# MATANUSKA-SUSITNA BOROUGH

## **ABBREVIATED PLAT AGENDA**

**May 14, 2025**

**STAFF REVIEW AND RECOMMENDATIONS  
PUBLIC HEARING  
MAY 14, 2025**

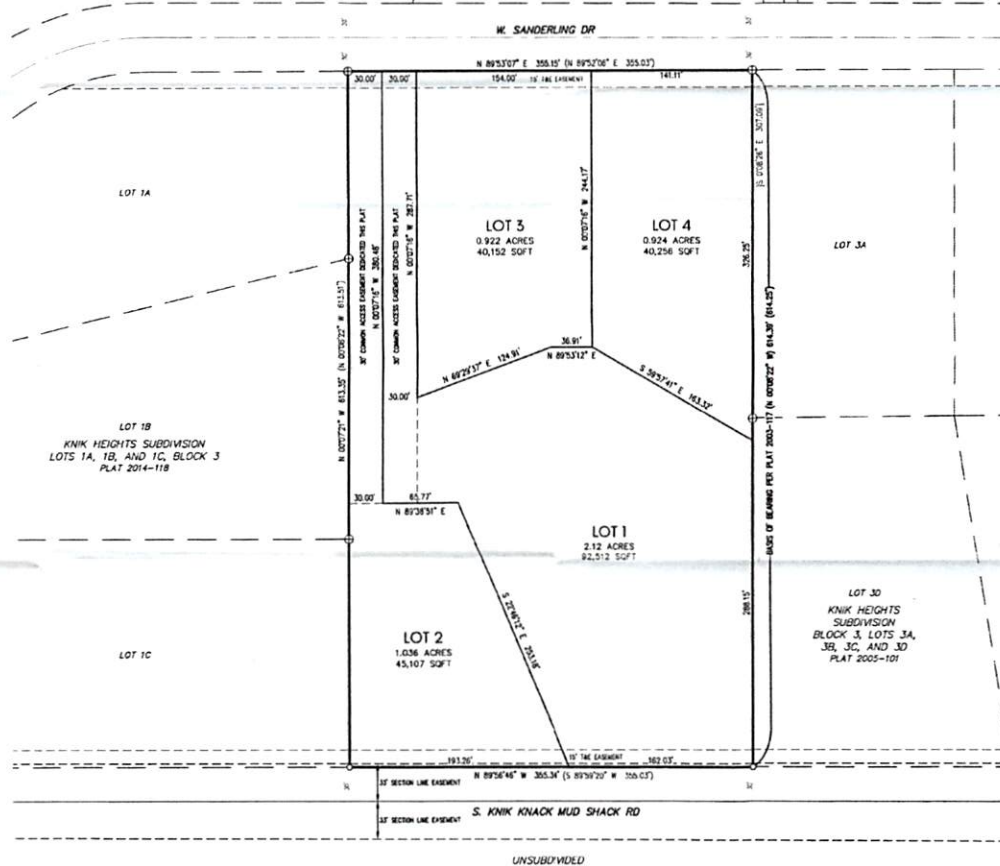
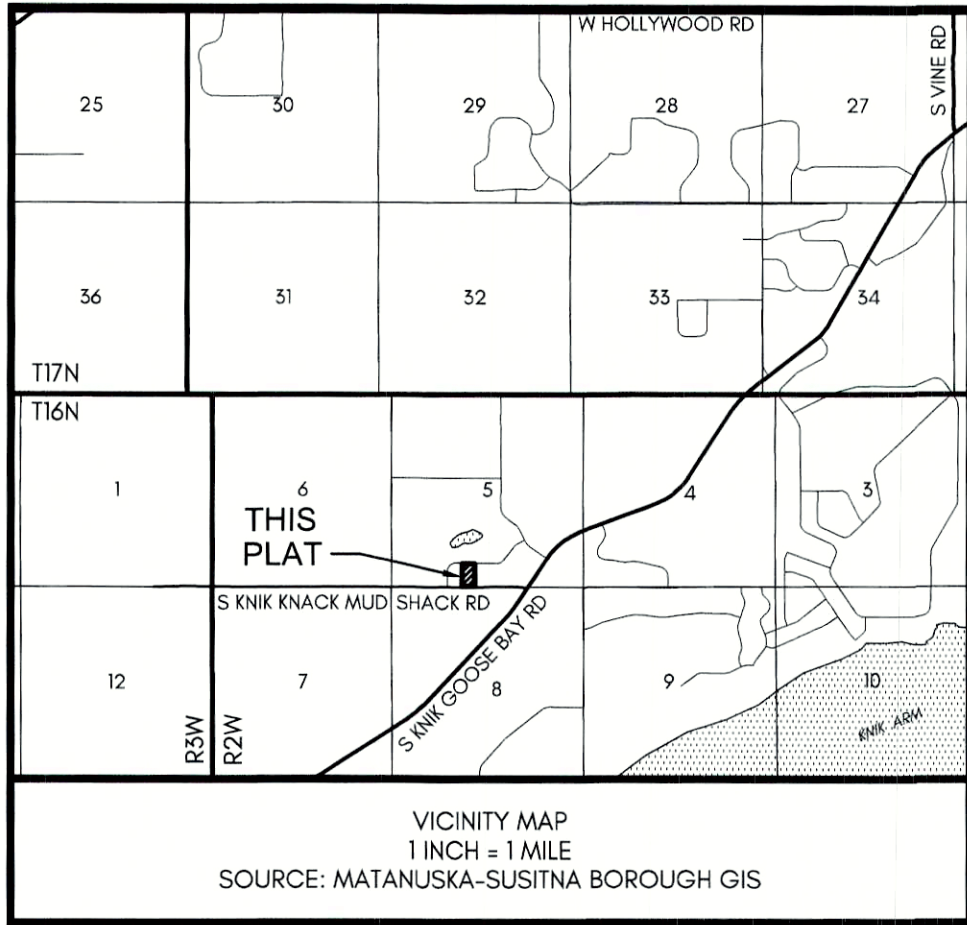
MSB Department of Public Works, Division of Pre-Design & Engineering (**Exhibit D**) commented, “PD&E recommends a common access easement be placed on the pole portion of the flagpole lots 2C and 2D. Since Knik Knack Mud Shack is classified as a minor collector on the OSHP and in accordance with 2022 SCM A04.3(b) PD&E recommends a plat note that there should be no access to Knik Knack Mud Shack Road from any of the proposed lots. The location of test hole 3 is at the top of a slope that is steeper than 25% and is therefore in an area that can not be counted as usable septic area. Since there is no available soils data representing usable septic area on Lot 2D, PD&E recommends additional soils information be submitted.” (See *Staff Recommendation #3 and #4*)

**Lot Design:** The existing design shows a 40' flag pole as part of Lot 2C. Lot 2C is larger than 3 acres and this flag pole portion must be a minimum of 60' wide and redesigned (see *Recommendation #2*) to comply with MSB 43.20.300 (E)(6) *Lot and Block Design*.

2. Adjust the lot design to comply with MSB 43.20.300 (E) *Lot and Block Design*. Changes could include either increasing the pole portion of Lot 2C to a minimum of 60' per MSB 43.20.300 (E)(6)(b), or reducing the lot size of Lot 2C to three acres or less to maintain the 40' wide pole portion per MSB 43.20.300 (E)(5)(b).
